TPB Ref.: A/YL-LFS/577

Proposed Temporary Open Storage of Construction Machinery & Construction Materials for a Period of 3 Years at Lots 1703 (Part) & 1704 (Part) in D.D. 129, Lau Fau Shan, Yuen Long, N.T.

Below is the response to the comments from GEO in their email dated 22 Jan 2026.

GEOTECHNICAL PLANNING REVIEW REPORT (GPRR)

Section B-B

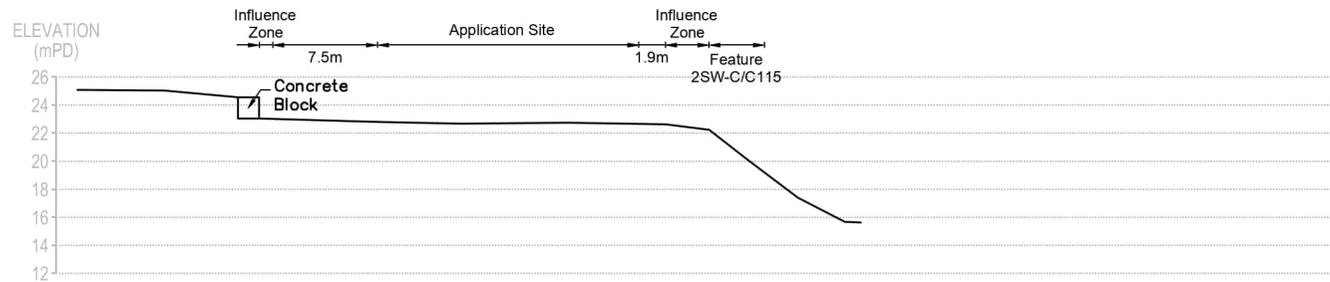
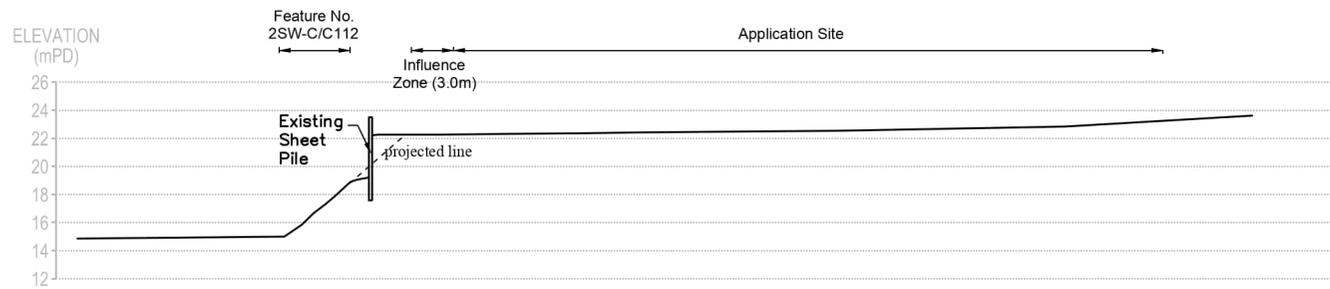
2. It is noted from Section B-B in Figure 5 of the GPRR that the sheet pile wall is supporting a newly formed platform located within the application site (see attached Plan B). The type of filling materials and extent of the newly formed platform should be investigated. The stability of the slope, sheet pile wall and the newly formed platform should be assessed and proposed rectification works should be provided, if found necessary.	As shown in Figure 3, only a short length of the sheetpile (i.e. 0.866m compared to the overall length of 16.8m) has entered into the Application Site. The boundary of the Application Site has then shifted back for a distance of 6.8m from the sheetpiles, which is beyond any newly platform formed and the crest zone recommended in GEO Technical Guidance Note No. 15 (TGN 15). In addition, drainage has been provided to avoid causing surface erosion to the slope.
